~~Preliminary and Final~~ **Drainage Report**

Clear View Properties I, LLC
Clear View Industrial Park Filing No. ~~2A~~

Remove Preliminary.
This is a Final
Drainage Report.

Name of this project
is: Clear View
Industrial Park Filing
No. 2B. Revise.

Worksheet for Triangular Channel - lot2a

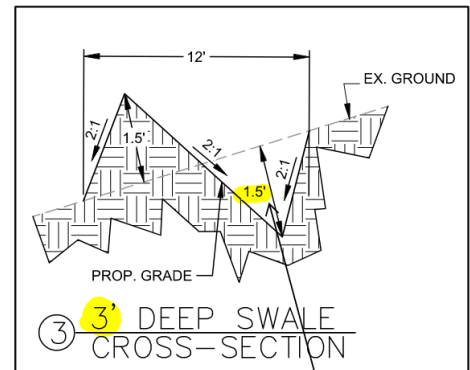
Depth of swale does on cross section is inconsistent with this drainage report. Revise.

GRADING, STORM AND EROSION CONTROL PLANS

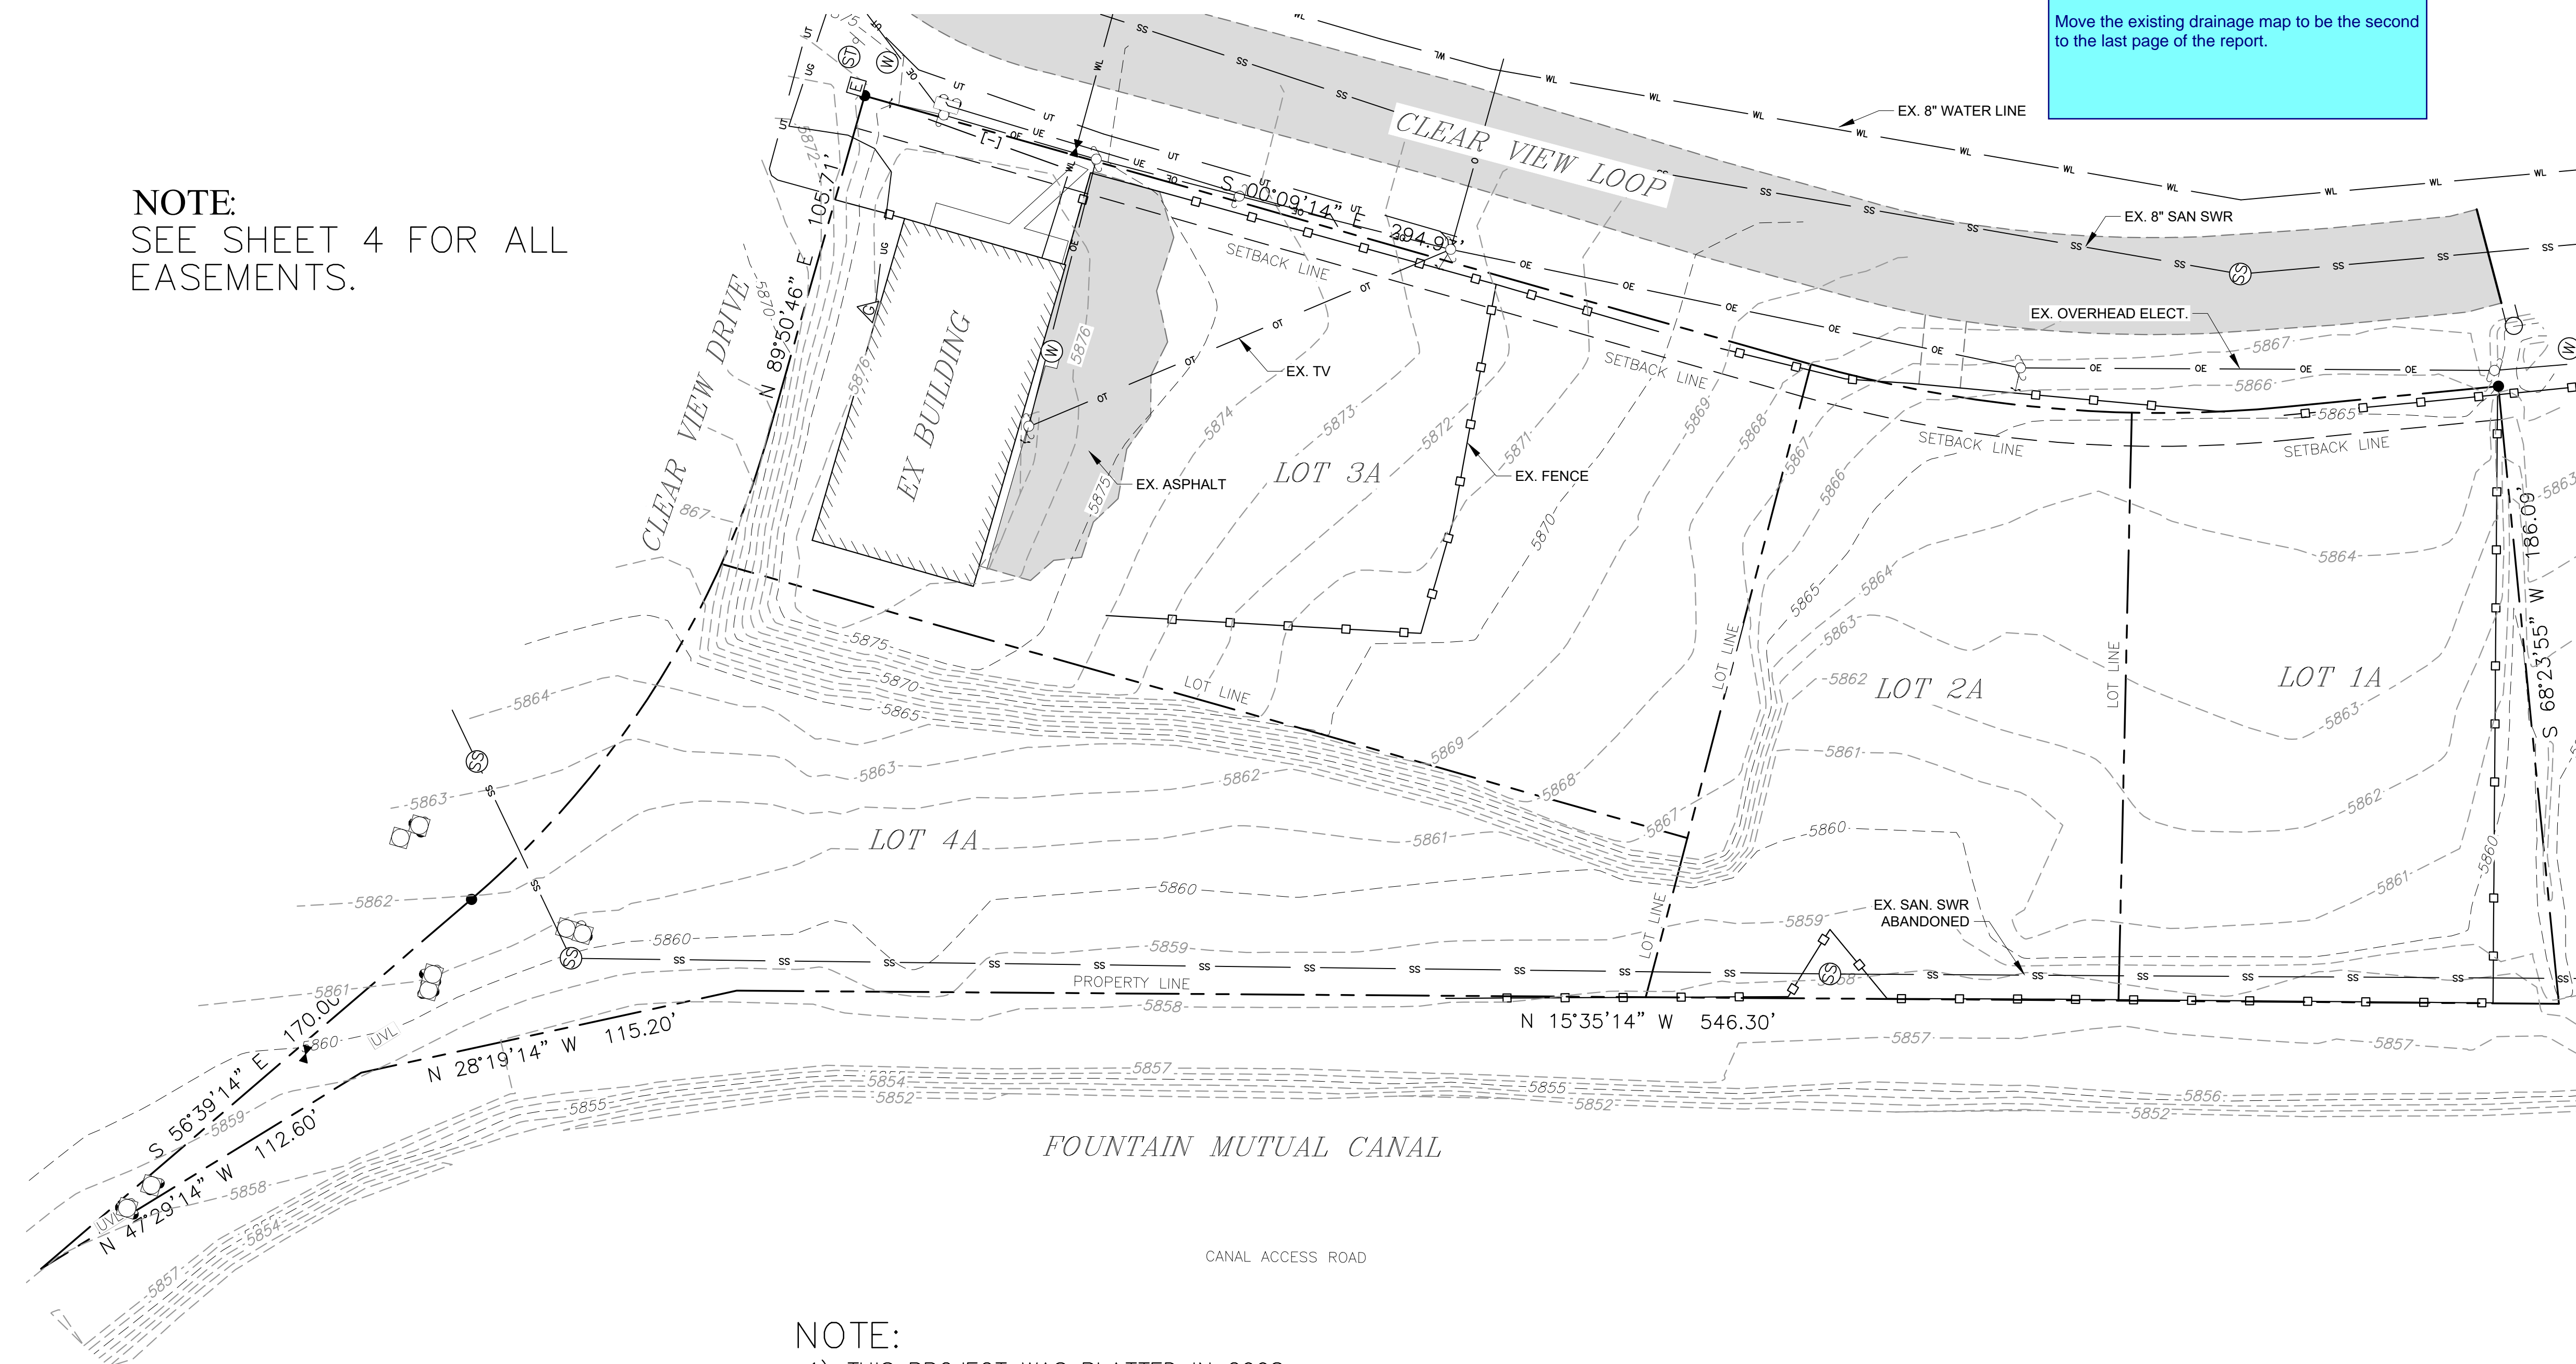
Remove and replace with an existing drainage map.
Move the existing drainage map to be the second to the last page of the report.

SHEET TITLE: DRAINAGE PLAN (PROPOSED)

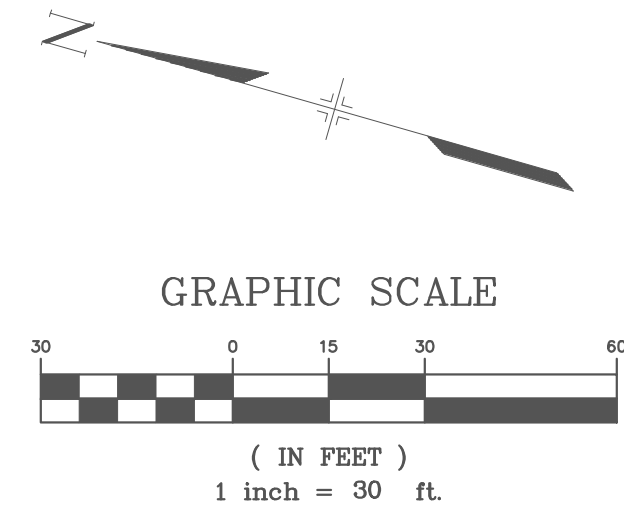
Add the offsite area
draining into the
pond. Pond shall be
designed to account
for the offsite area.
